WWTP Expansion Report

(Work Order No. 101)

Prepared for:
Inscription Canyon Ranch Sanitary District
P.O. Box 215
Chino Valley, Arizona 86323

Prepared by:
Granite Basin Engineering, Inc.
1981 Commerce Center Circle, Suite B
Prescott, AZ 86301

**PROPOSED WWTP
SITE PLAN
APN: 306-55-029G & 100B**

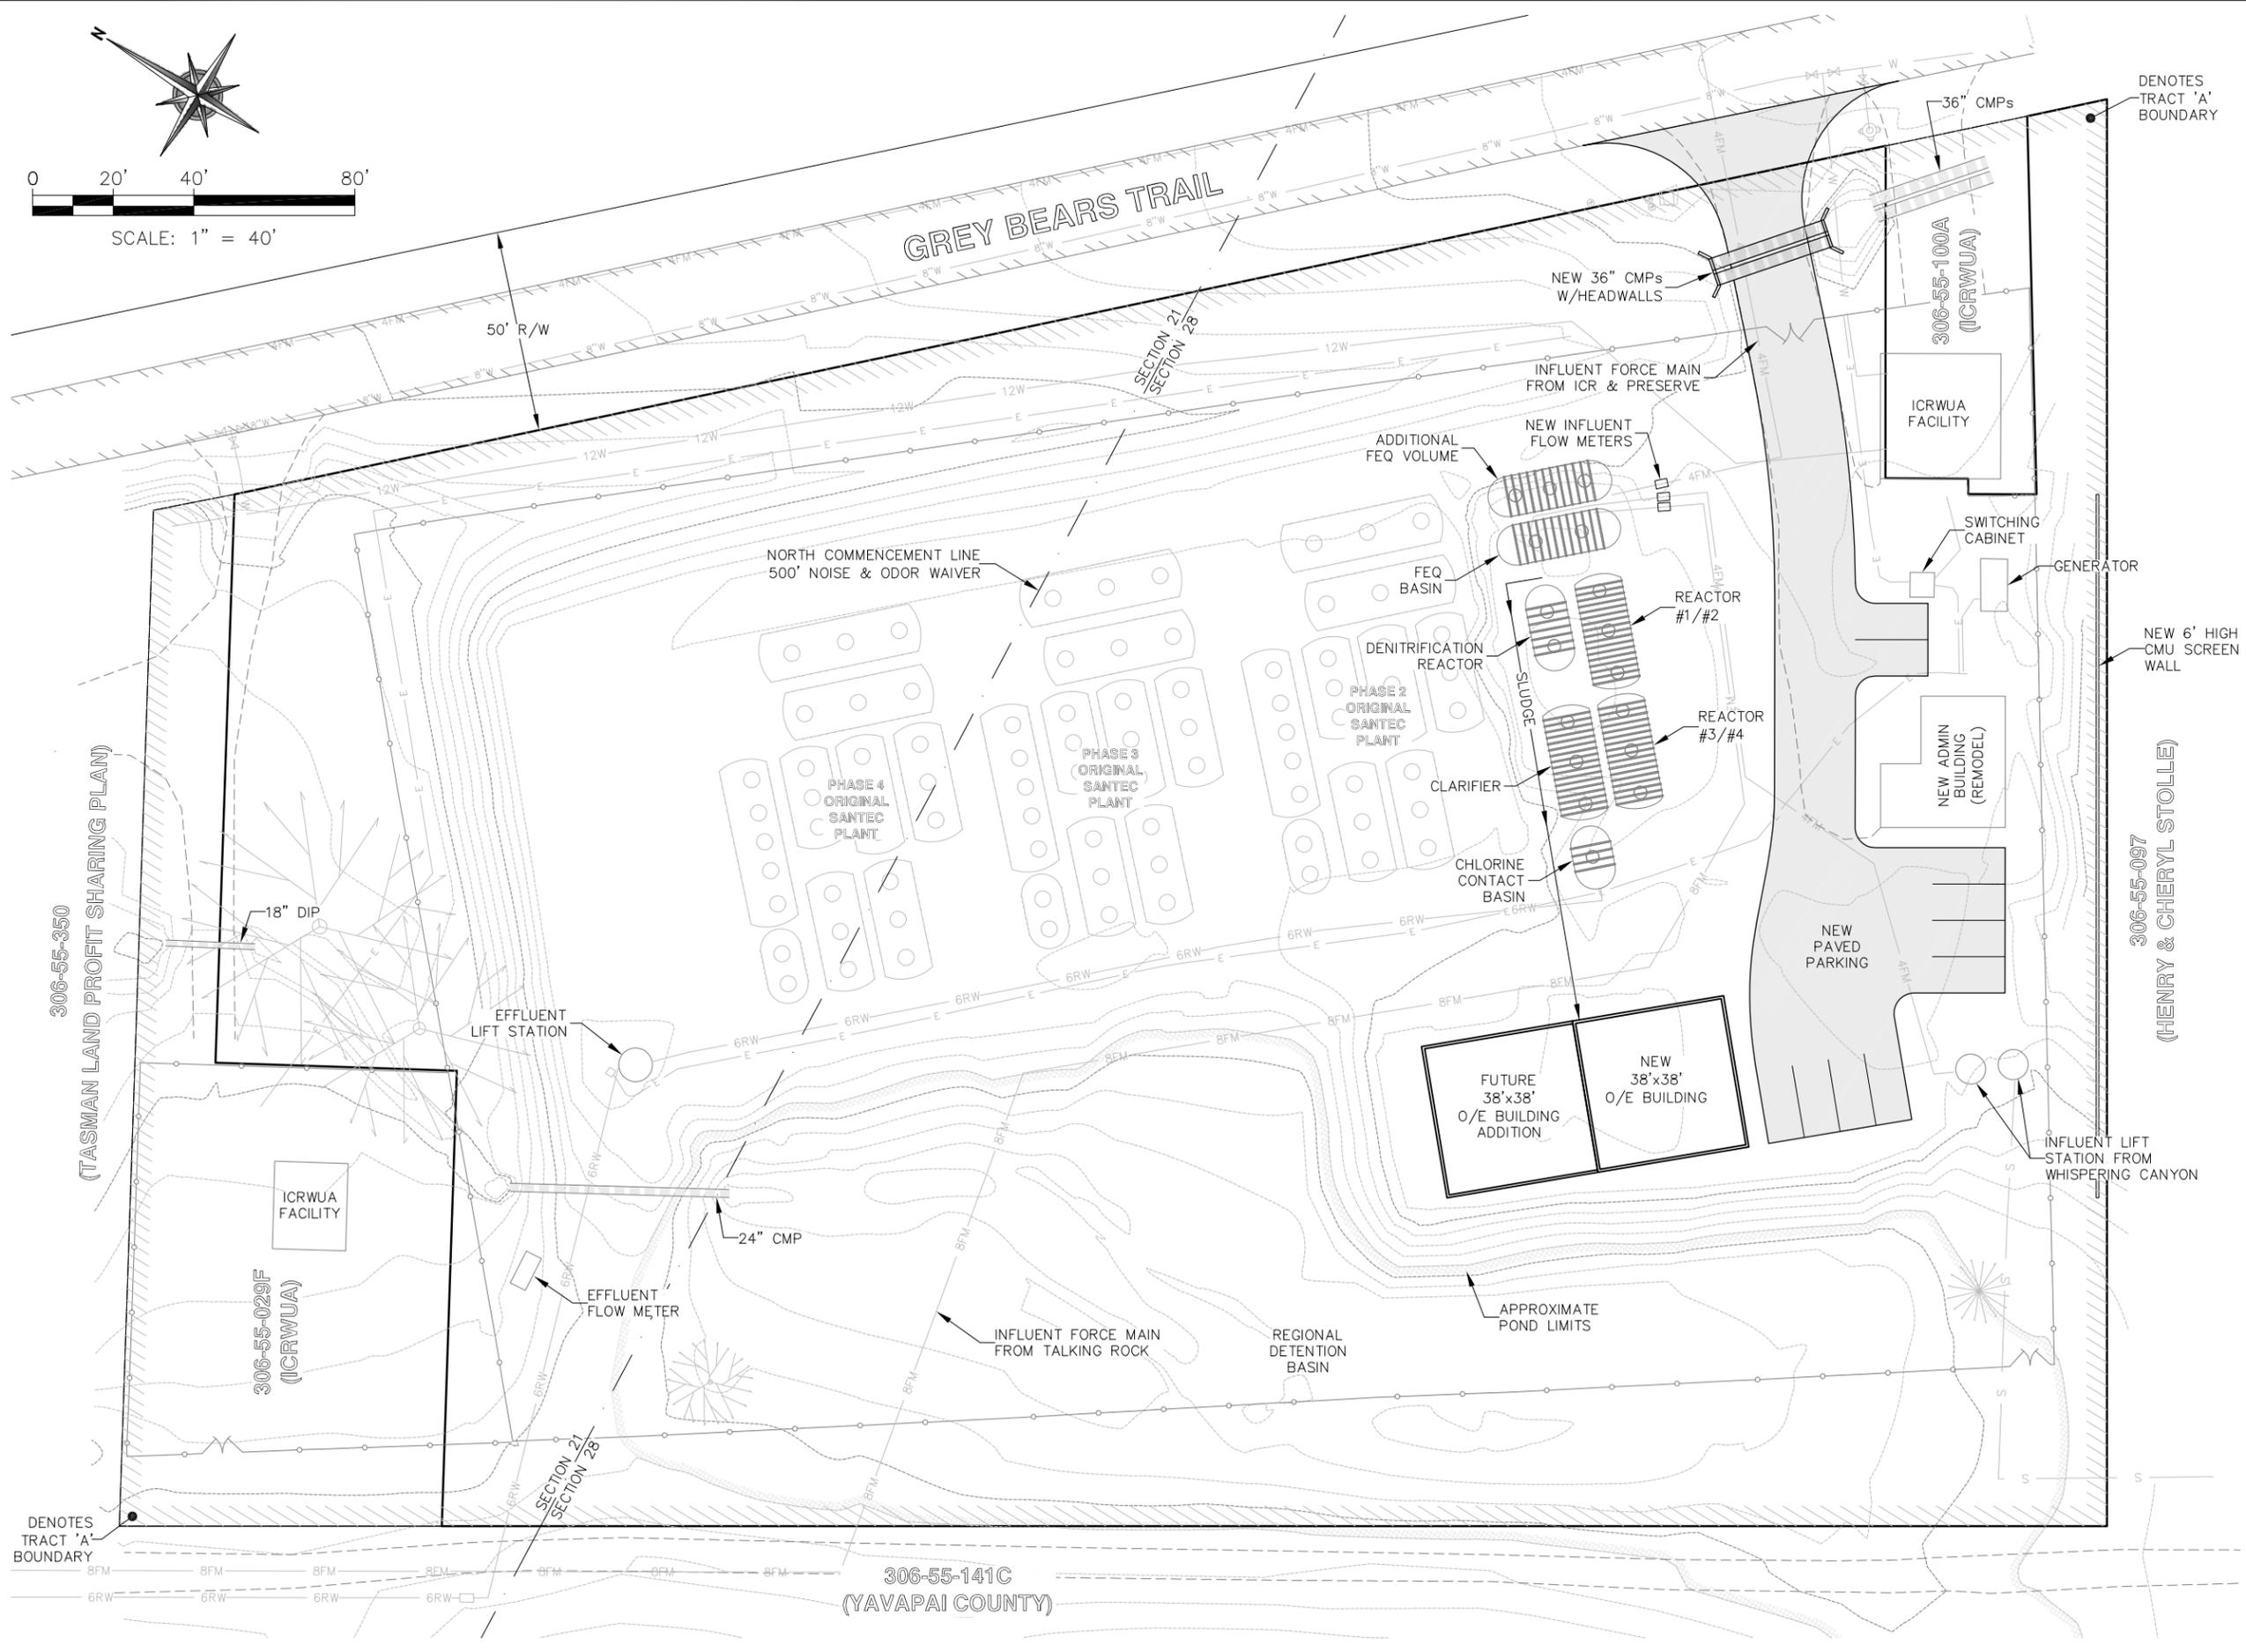
We believe the closure plan should be done in order to properly decommission this obsolete facility. Remnants of the old SBR are a major hindrance to site development and future plant expansion(s).

The existing culvert structure consists of two (2) 30” corrugated metal pipes located immediately downstream from two (2) 36” culverts. We recommend the culverts be replaced to match the upstream structure, with concrete headwalls to improve flow transition through the structure.

Site grading is recommended to flatten the area where the concrete basins are located and filling in the old polishing pond. This will create a significant amount of usable space on the site for additional parking, future building(s) and future plant expansion(s).

Paving and parking improvements are recommended to improve site access, parking availability and dust abatement.

A screen wall along the south property line will provide a buffer for the adjacent residential property. This wall will provide both visual and noise buffering.

It is recommended that a new O/E building be constructed at the site of the old SBR concrete tank site. This would create a larger buffer from adjacent residential properties and may be necessary to contain a new sludge handling system. This building would also contain the control systems for the existing WWTP. Please note that it is possible for the new sludge handling system to be located within or adjacent to the existing O/E building with construction of a shed roof to cover the equipment.
